1963 - 1965 Corvette: Service Bulletin: Drive Line Noise

Source: Chevrolet Technical Service Bulletin

Bulletin No: #1069

Date: January 7, 1965

PART I - Re-work of Bracket Part No. 3820186

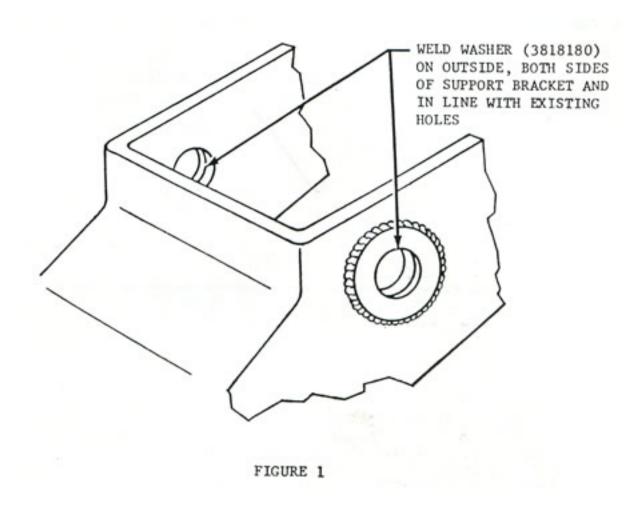
A clunking noise may occur in the drive line of some 1963-65 Corvette on initial vehicle movement in either forward or reverse gear. This could be caused by loosening of the differential carrier support bracket front attaching bolts. Loosening of these bolts will also result in elongation of the bracket bolt holes.

If elongation of bracket bolt holes occur, the differential carrier bracket should be replaced with bracket Part No. 3868799. However, the original service bracket Part No. 3820186, can be used by reinforcing it as shown in Part I of this bulletin. In conjunction with the installation of the bracket, it will be necessary to secure the forward attaching bolts as outlined in Part II of this Bulletin.

1. If reinforced bracket, Part No. 3868799 is not available, obtain Part No 3820186 and weld one flat washer, (Part No. 3818180) on each outside surface in line with existing holes (See Figure 1.)

PART II - Safety Wire Procedure

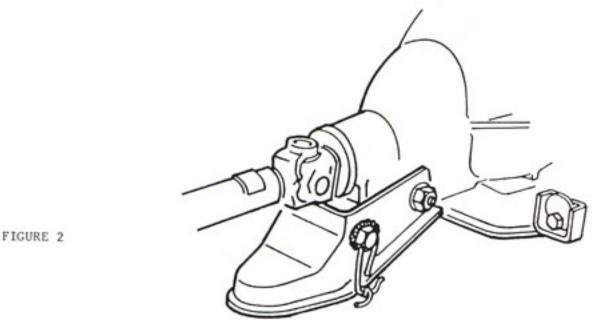
NOTE: Be sure the straight wire form the bolt head to the flange hole is on the tightening side of the bolt. (See Figure 2).

- 1. Obtain (2) 7/16-14 x 1 300M bolts and drill a 3/32 inch diameter hole through the head of each.
- 2. Drill a 3/32 inch diameter hole through the lower flange of the carrier bracket directly below the forward bolt hole (both sides of bracket).

- 3. Install new bracket using modified forward attaching bolts. Torque forward attaching bolts to 65 ft. lbs.
- 4. Safety wire the forward bracket bolts to the bracket with stainless steel safety wire (1/16 inch O.D.) or stainless steel welding rod (1/16 inch O.D.).

5. Tighten the wire sufficiently by twisting the ends together. NOTE: Overtightening will cut the wire at sharp bends.
